**RFI**

RFI #: 100  
 Date: 4/9/2012  
 Job: EB-02 Keller Springs Lofts  
 Phone: 877-777-5115

CC: Trent Perkins (Parkin Perkins Olsen)  
 Subject: E1 Unit - Wet Wall Behind Toilet

Drawing: A2.1  
 Cost Impact: None

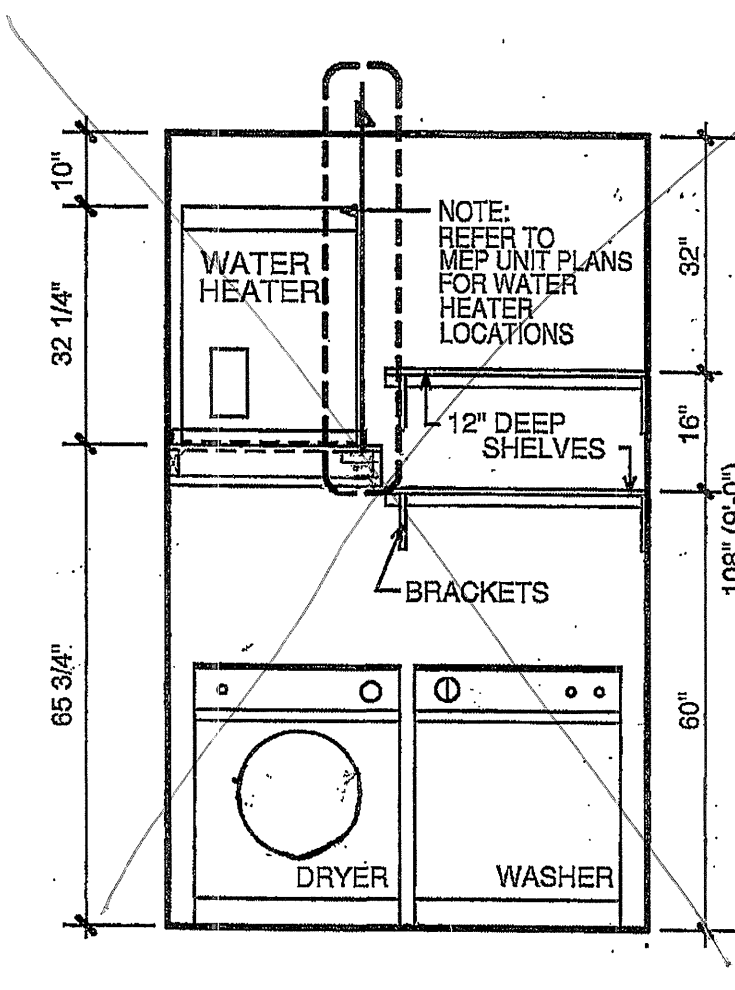
Request: Date Required: 4/11/2012  
 It seems that the wall behind the toilet needs to be a 2x6 wall. Please confirm.

Response:  
 Unit E1 has been updated.  
 Please see next page of this PDF.
